ENVIRONMENTAL REVIEW TEAM REPORT

SALEM ROAD WETLAND PROSPECT ,CONNECTICUT KING'S MARK

**SALEM ROAD WETLAND
APRIL, 1984**

FIGURE 5 GENERAL VEGETATION MAP

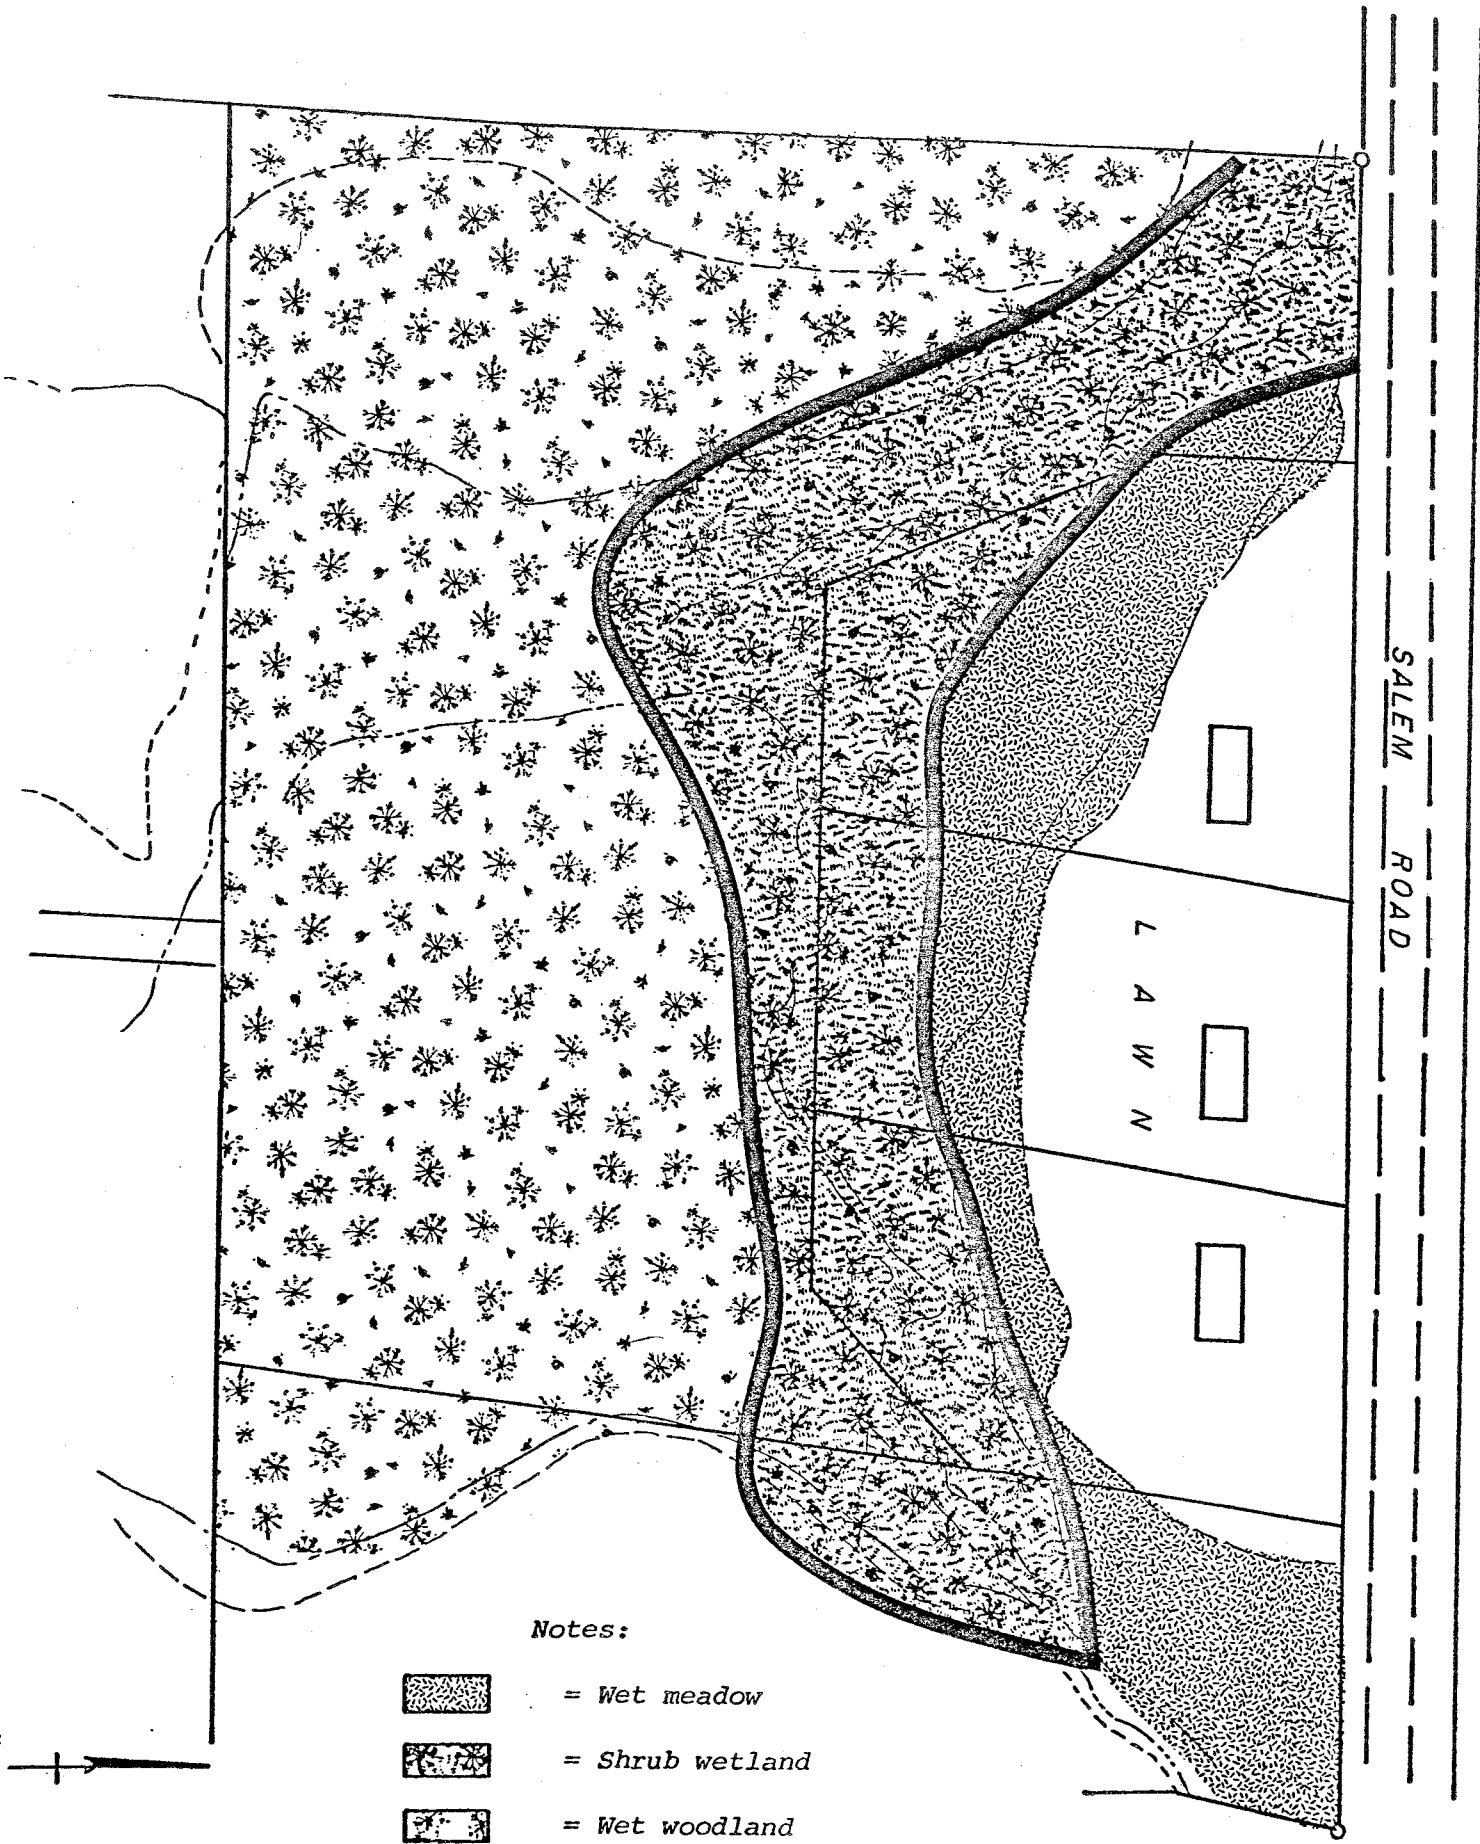
The vegetation on the project site occurs in three distinct zones (see Figure 5). Extending southward from the roadway at the east end of the parcel and from the toe of slope of the lawn is a wet meadow. Forbs and grasses which are well-adapted to wet environments dominate the meadow. That the meadow supports a preponderance of non-woody species is apparently a function of the recent clearing of the site for housing construction.

In consultation with Civil Engineer Steven Derby and Geohydrologist Bill Warzecha, the Team's biologist was advised that the proposed channel deepening would have the effect of drying-out the areas immediately adjacent to the streambed. Such alterations in the water regime frequently result in invasion by common reed grass (Phragmites australis) and, in drier areas, Japanese knotweed (Polygonum cuspidatum). These species have very little wildlife value, and few species can feed on them or use them as nesting sites. Phragmites is also a fire hazard.

If the project goes forward, any Phragmites which appears should be removed by hand, and then the site should be replanted with more productive cattails. Rhizomes have been found to be more effective in establishing cattails than seeds alone, but existing cattail stands should not be denuded for the sake of revegetating the project site. Rather, no more than one propagule per square yard should be taken, and rhizomes should be planted no more sparsely than 1.5 feet off-center.
